Final Drainage Report - Amendment No. 1

Widefield Parks and Recreation Facility Expansion El Paso County, Colorado

PCD File Number: PPR-2213

DETENTION BASIN OUTLET STRUCTURE DESIGN

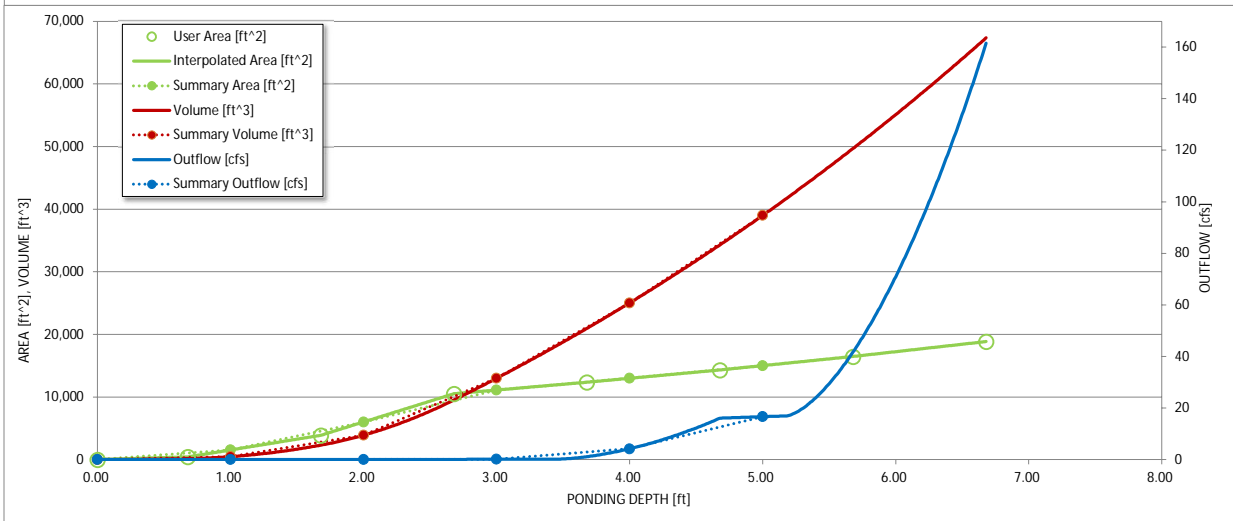
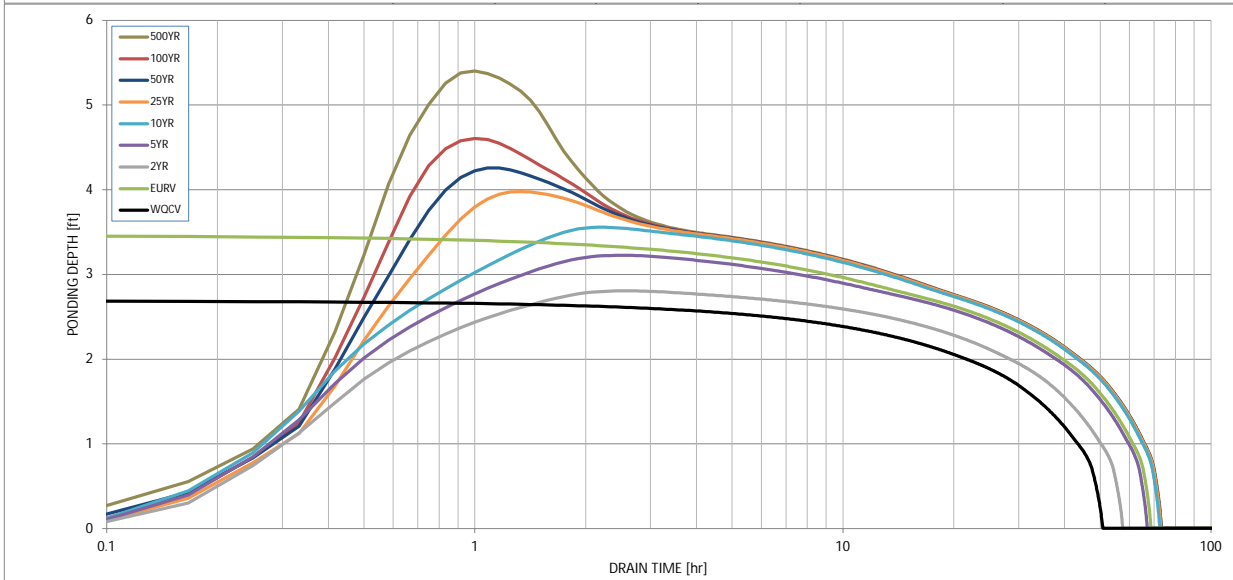
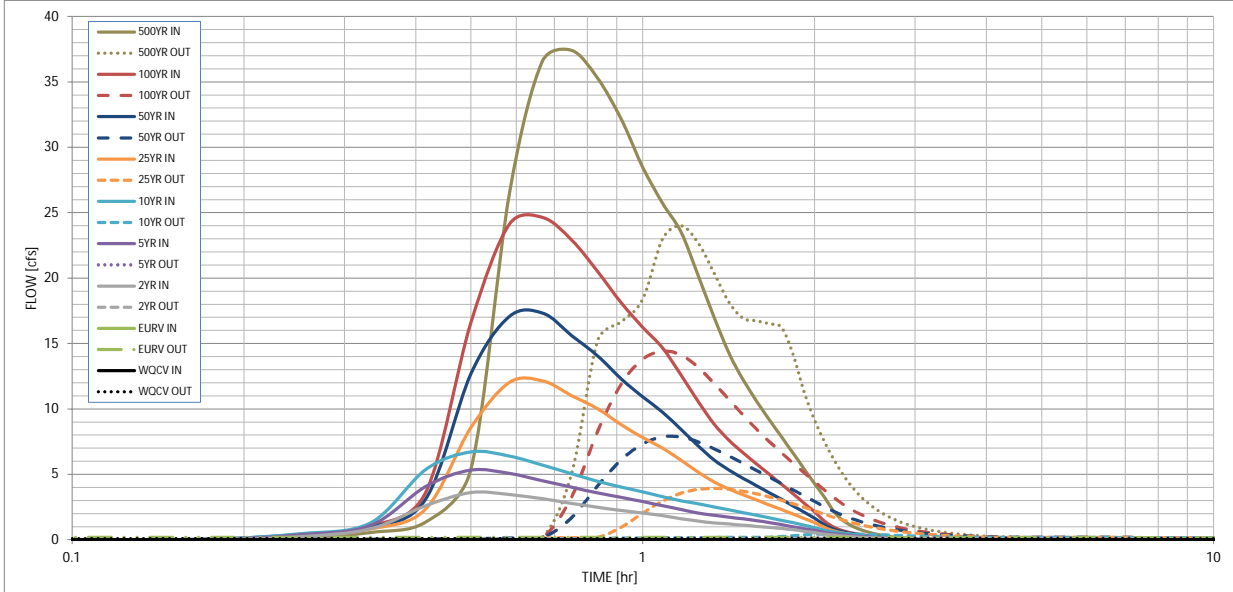
Shown as 4ft on detail on last page below.

Neither matches what is shown on detail on last page below.

Revise to 24"

SUMMARY - PROPOSED RUNOFF TABLE

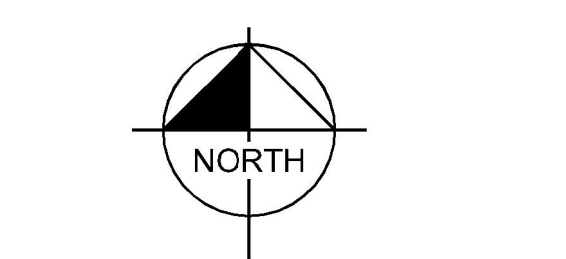
Update table for these 2 basins since more impervious service has been added in the parking areas on N and S side of bldg
 The calcs that need to be re-done and included in this addendum can be found on page 48 of 91 of the previously approved FDR for this project.

POND DETAILS

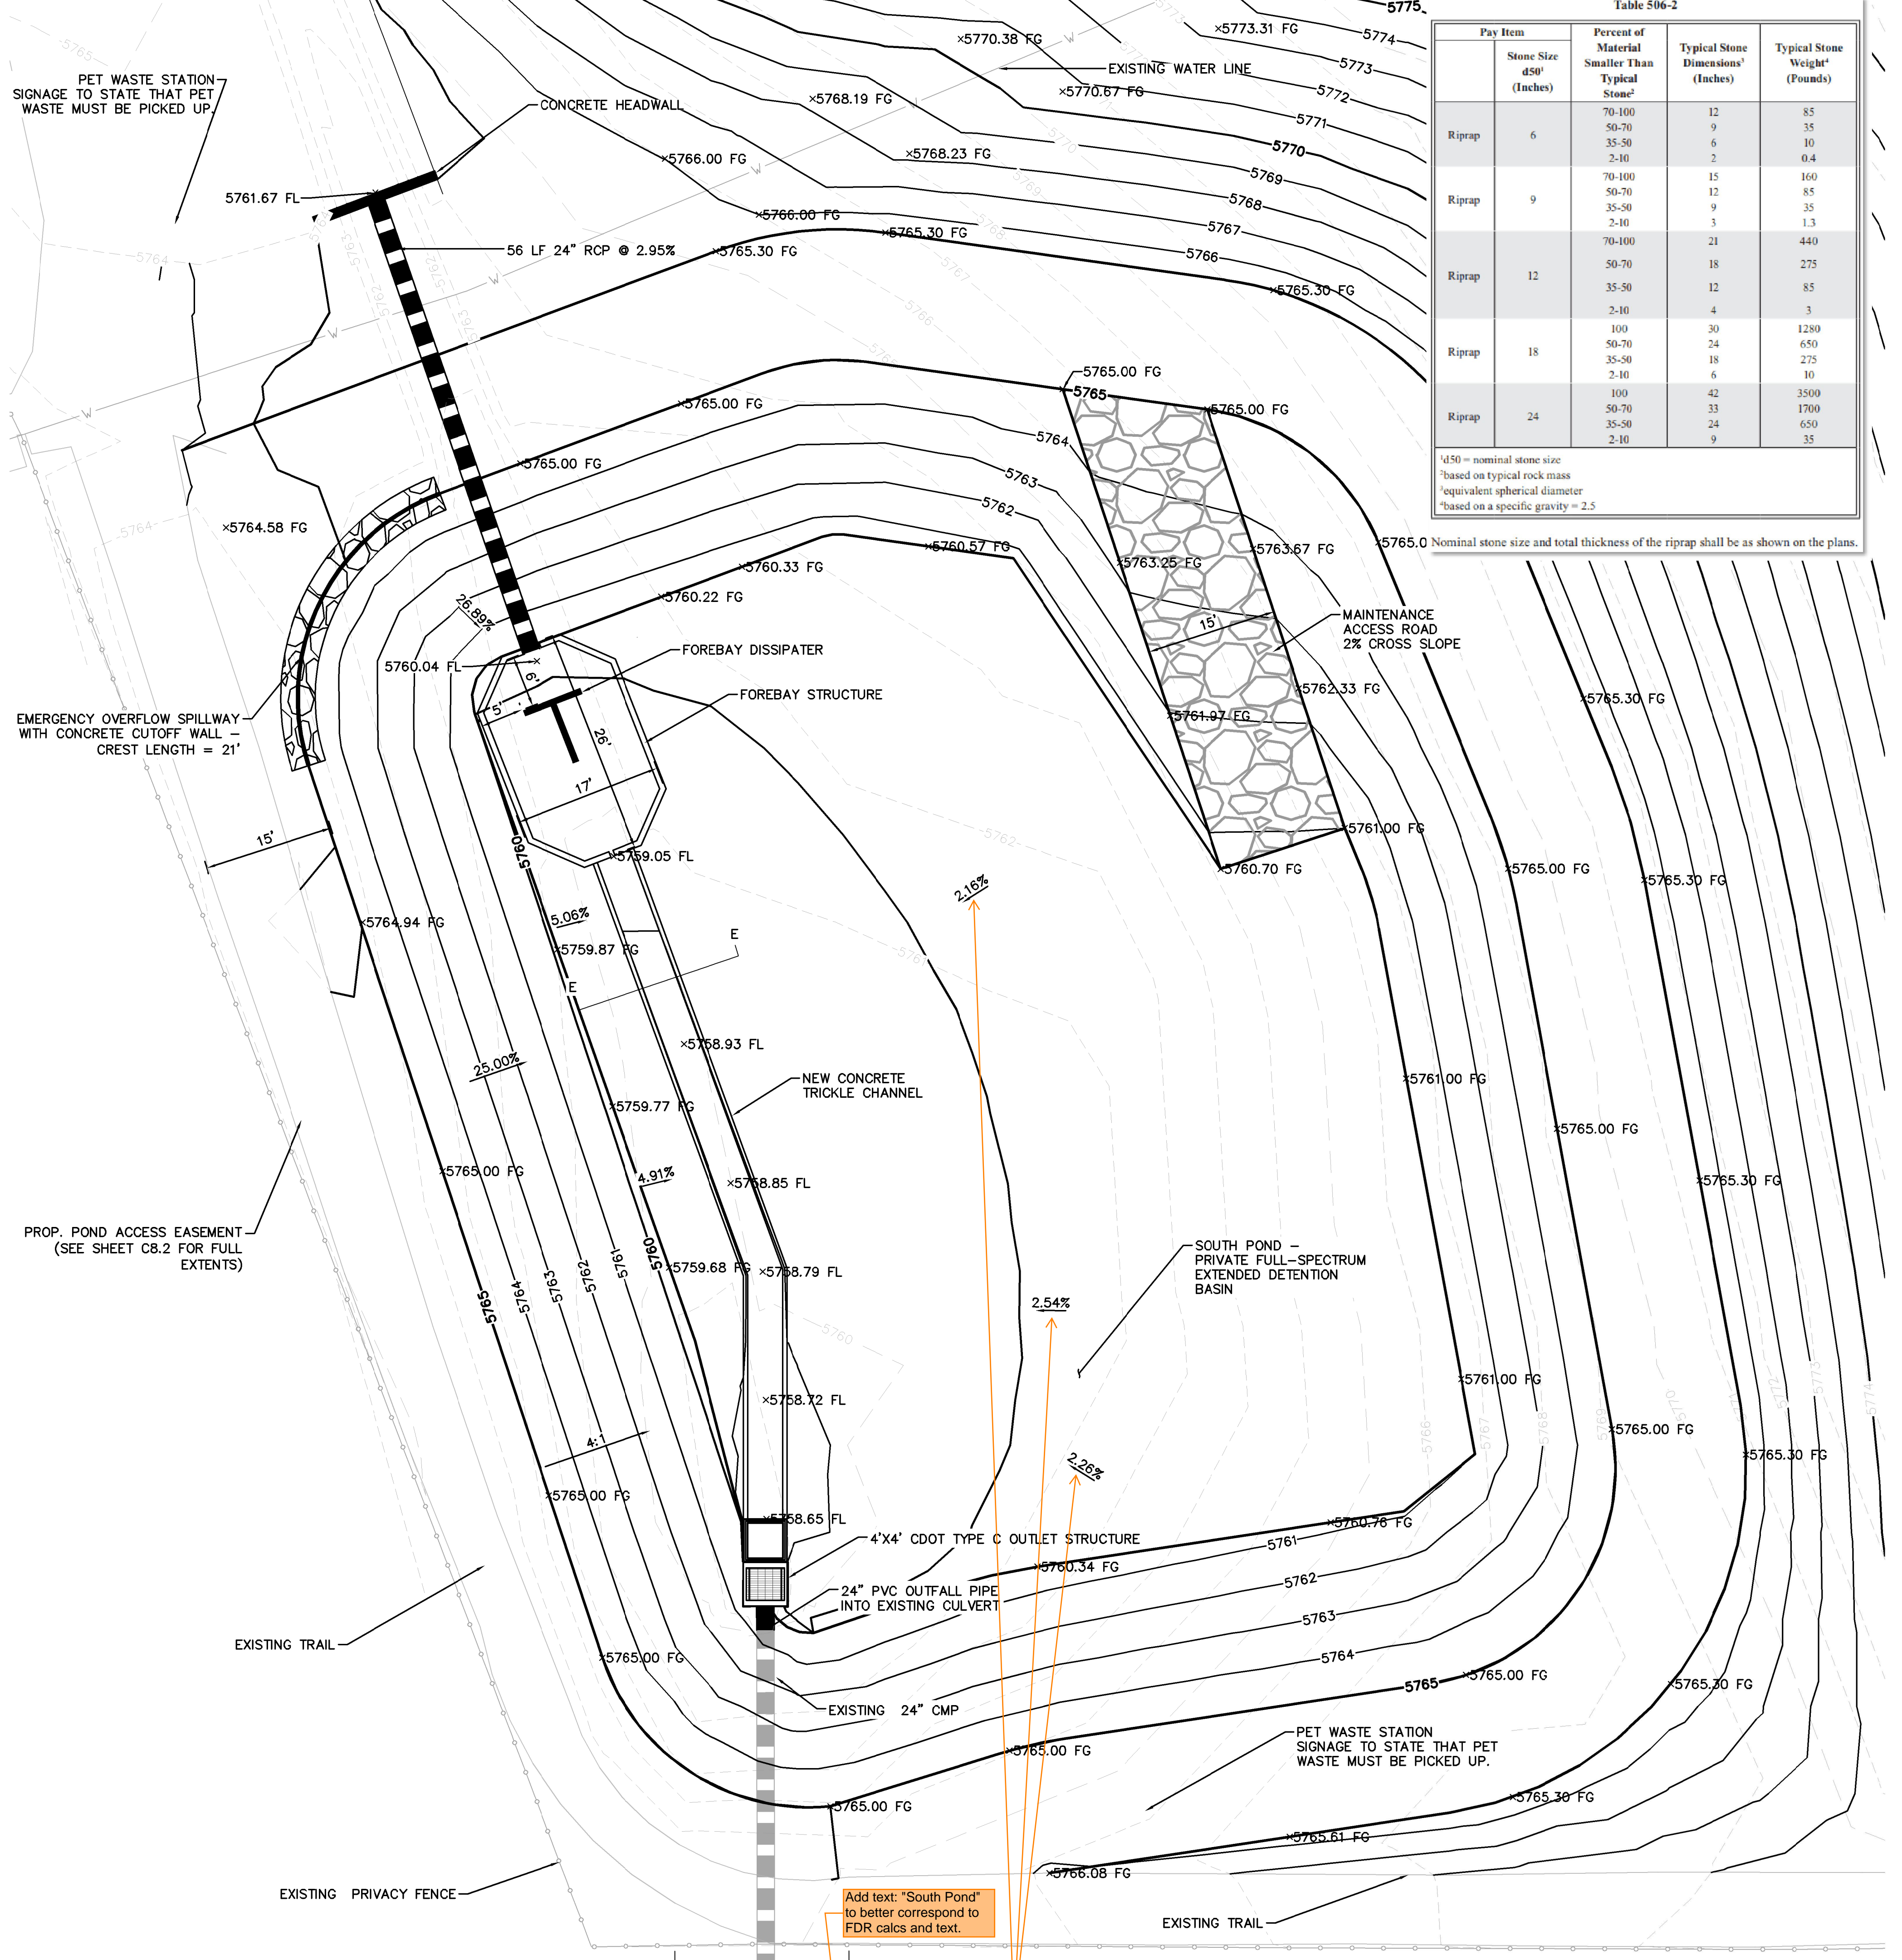
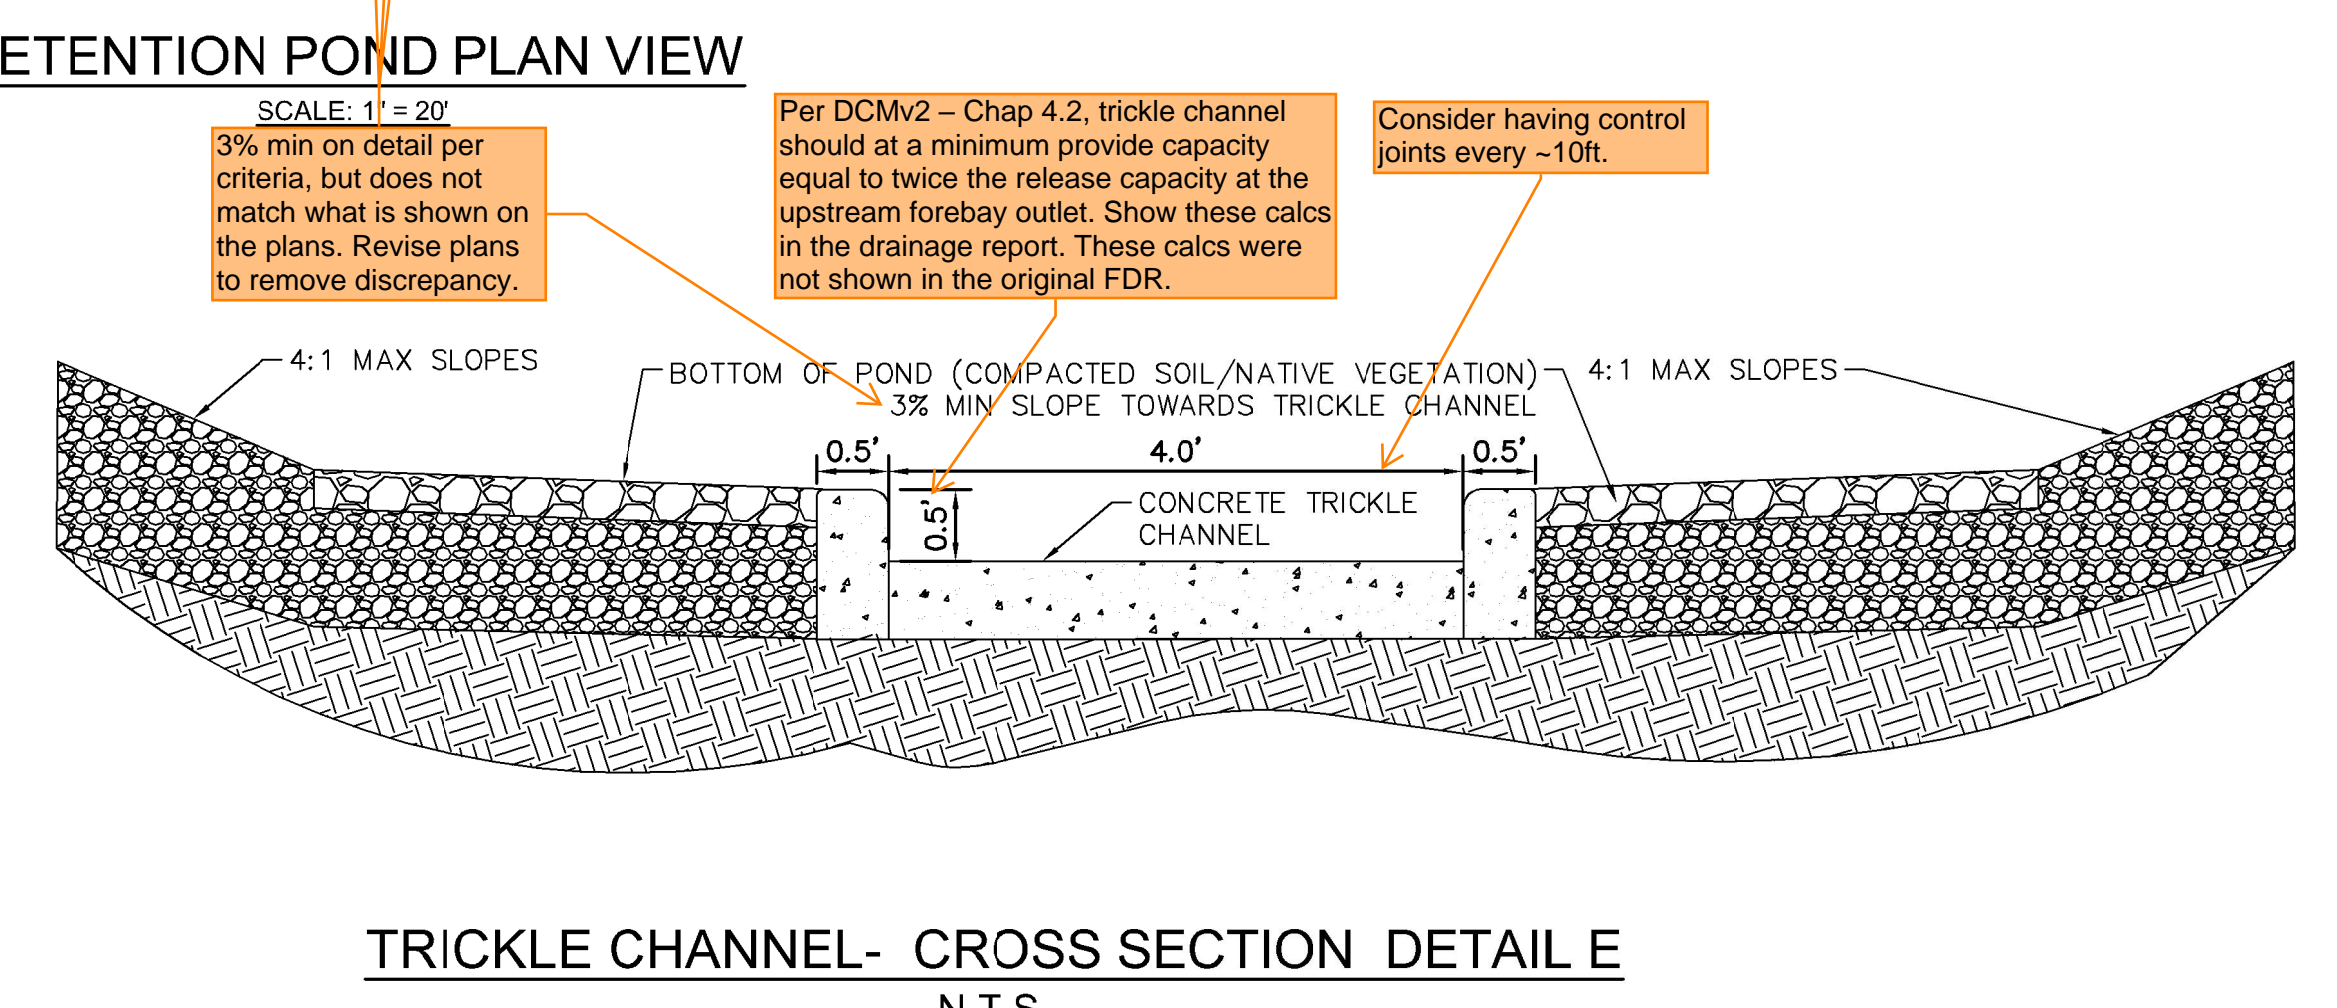
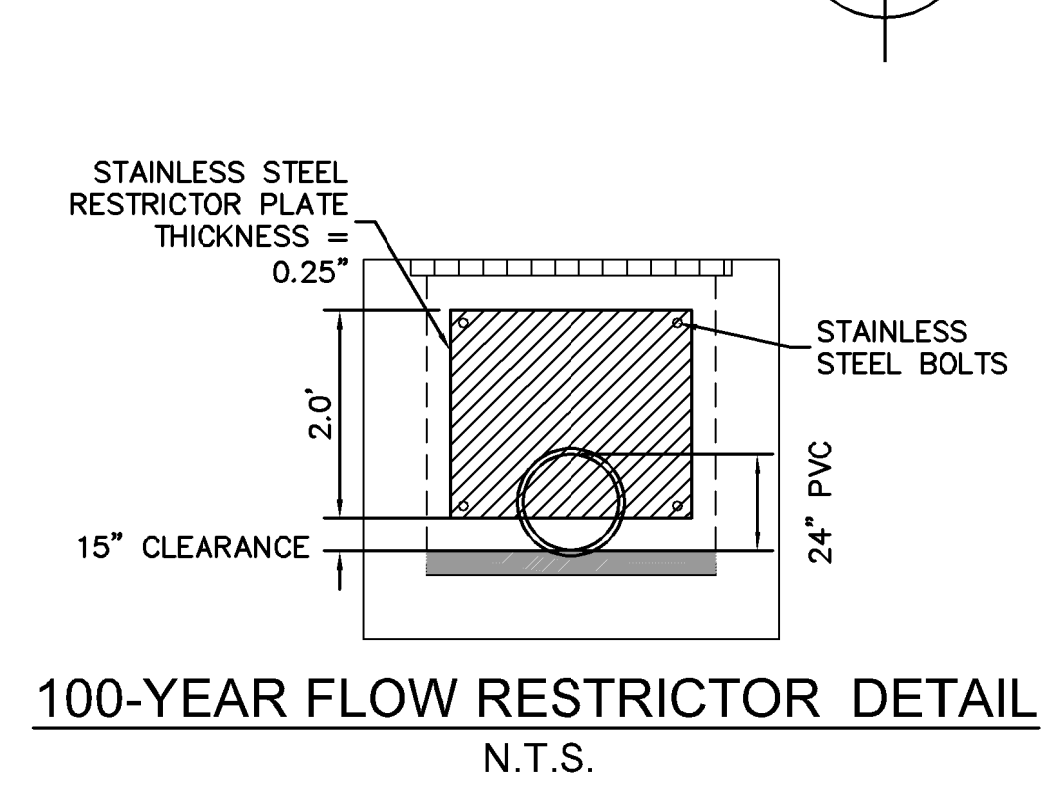
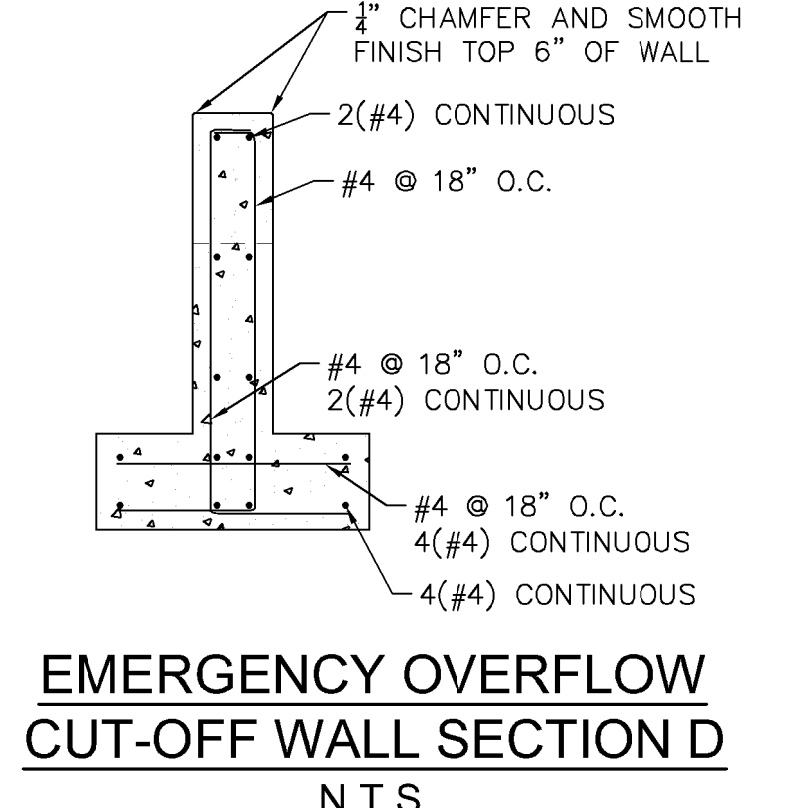
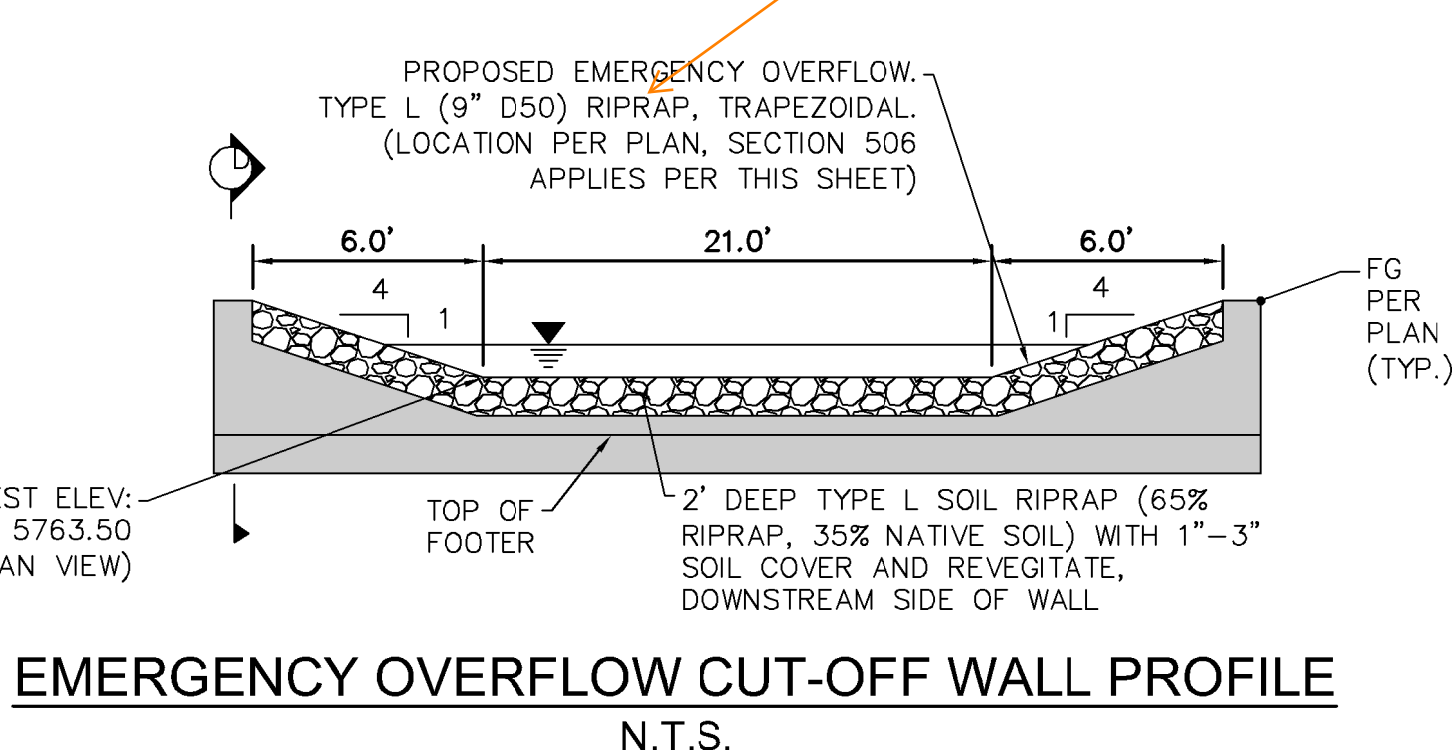
Also re-do UD-BMP spreadsheet to include the change in Effective Imperviousness and to the WQCV. This may subsequently effect the sizing of the forebay, which would need to be reflected with revisions on this detail.
